Luton Airport 19mppa Noise

December 1st 2021

Luton Borough Council Committee Meeting

Luton Airport: 2012 vs. 2021 ES Forecast of mppa and 48dB LAeq Night Contour Area

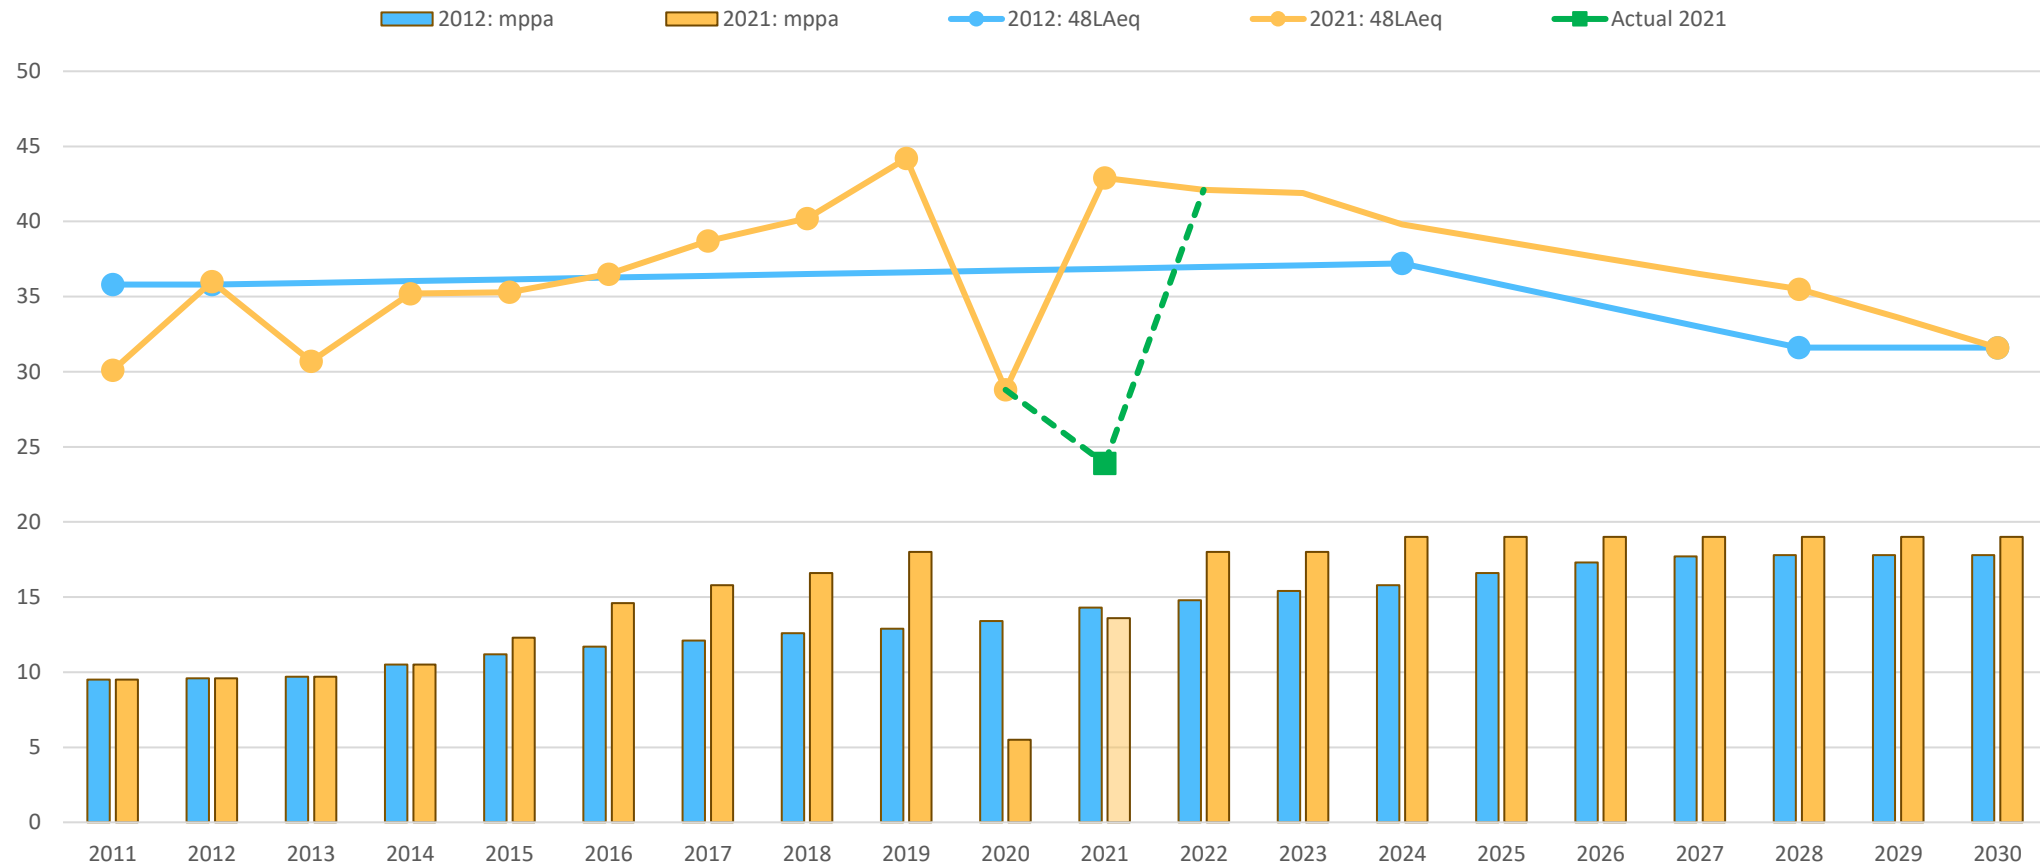
- The growth in passenger numbers and, therefore, ATMs has been much quicker than anticipated.
- As a result, noise levels and associated contour areas have been higher than forecast between 2013 and 2019.

- 18mppa was achieved in 2019, 9 years ahead of the originally forecast 2028.
- 2019 noise levels were higher, even with a lower ATM figure, than forecast for 2028 and the contour limits set out in Planning Condition 10 have been exceeded in the years 2017 to 2019.

- The principle reason for this is that new, lower noise aircraft have not been introduced at a rate that has kept pace with the rate of increase in ATMs.

- These facts were known before the 19mppa application was made.
- The effects of Covid 19 on the passenger numbers in 2020 and 2021 can clearly be seen.

- The rebound suggested for 2021 according to the 19mppa ES forecasts has not materialised, so the projected passenger and noise figures in the following years may be different to what is shown.

- However, the commitment for the reduced contour limits to be achieved still holds, albeit 3 years after the originally forecast 2028. The delay is principally due to Covid 19 effects.
